Application for Works Approval

Part V Division 3 of the *Environmental Protection Act 1986*

Works Approval Number	W6586/2021/1
Applicant	Oasis @ Newman Pty Ltd
ACN	612 951 710
File number	DER2021/000388
Premises	Oasis @ Newman 44 Great Northern Highway Newman WA 6753 Legal description Lot 44 on Deposited Plan 171724 As defined by the premises map attached to the issued works approval
Date of report	22/03/2022
Proposed Decision	Works approval granted

Figure 4: Total available area for disposal of blended effluent

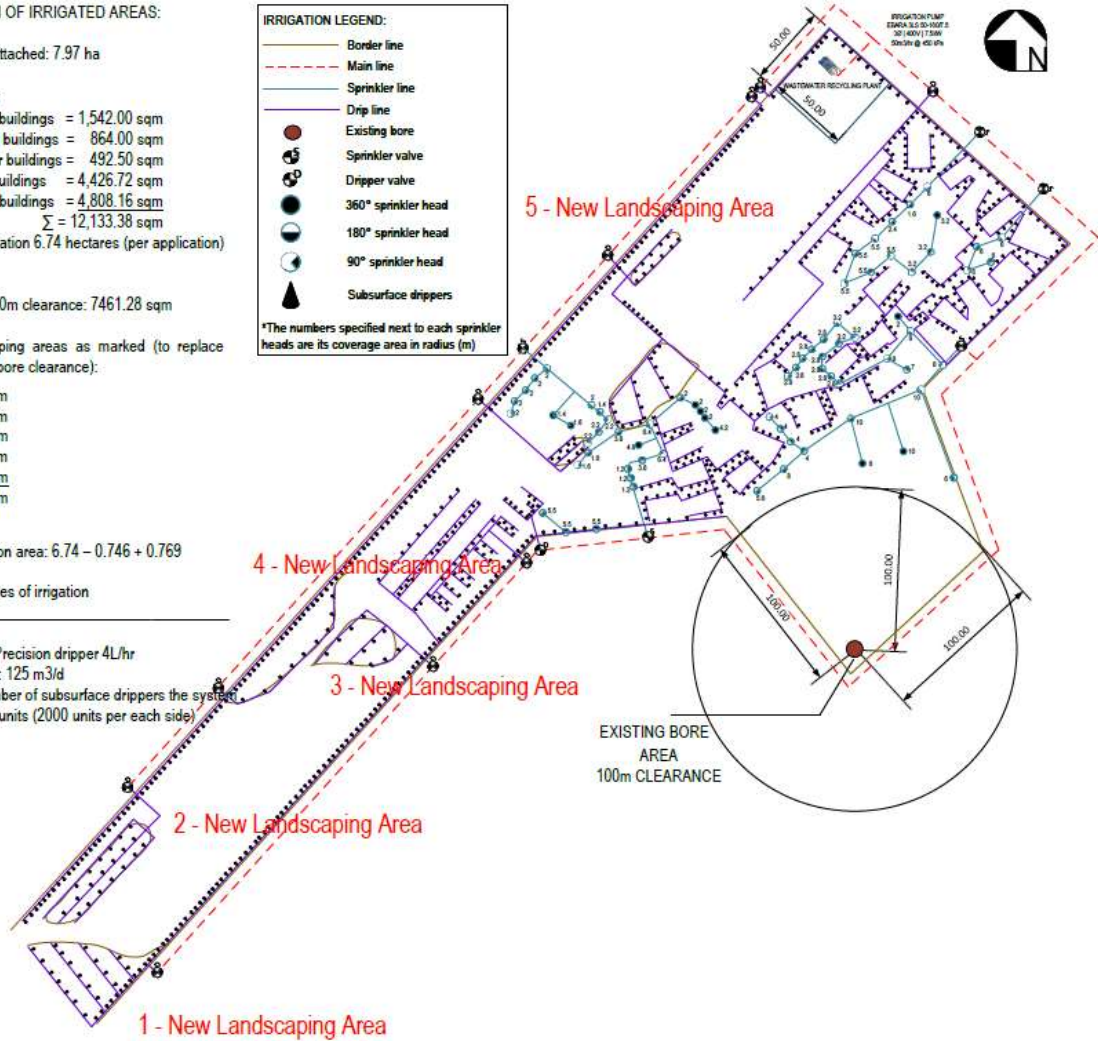
- The Delegated Officer notes that the blended effluent stream consisting of the anticipated actual throughput volume of the WWTP (178.8 m³), and the anticipated RO brine production (33 m³) will have a required area of disposal (52,950 m²) less than the actual available area (67,400 m²).

Figure 5: Soil sample locations – BH1 (green) BH2 (orange) and BH3 (yellow)

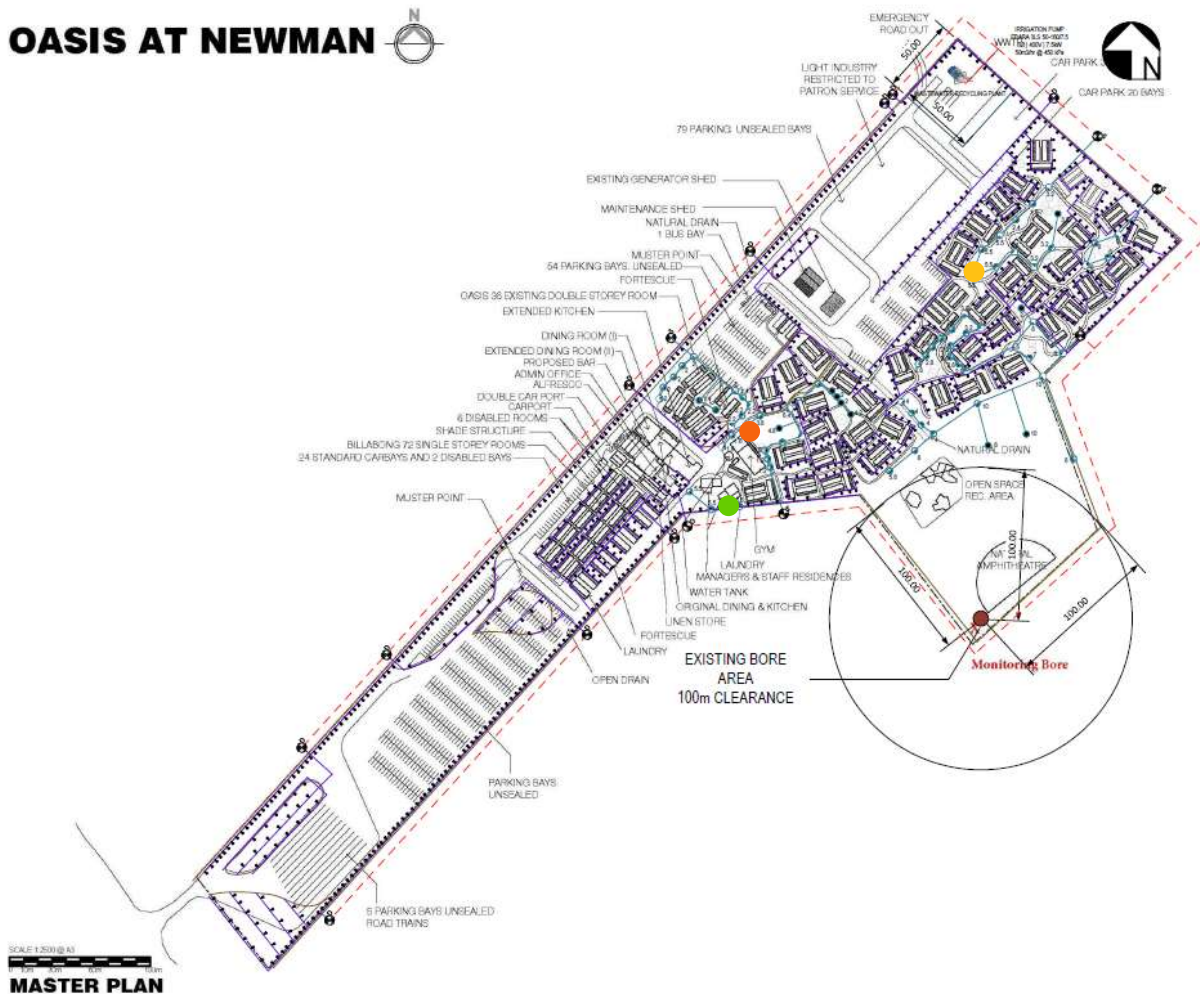
14. The Delegated Officer notes that no information has been provided regarding soil nutrient retention capacity.
15. The Delegated Officer notes that the total phosphorus anticipated process limit from the WWTP, and hence anticipated application rate via irrigation, are comparable to the total phosphorus soil nutrient concentration, outlined within WQPN 22.

16. The Delegated Officer notes that the nitrogen and phosphorus concentrations within soil samples obtained prior to irrigation will provide a baseline for soil concentrations should any concerns with nutrient loading within soils be raised during operation of the WWTP.
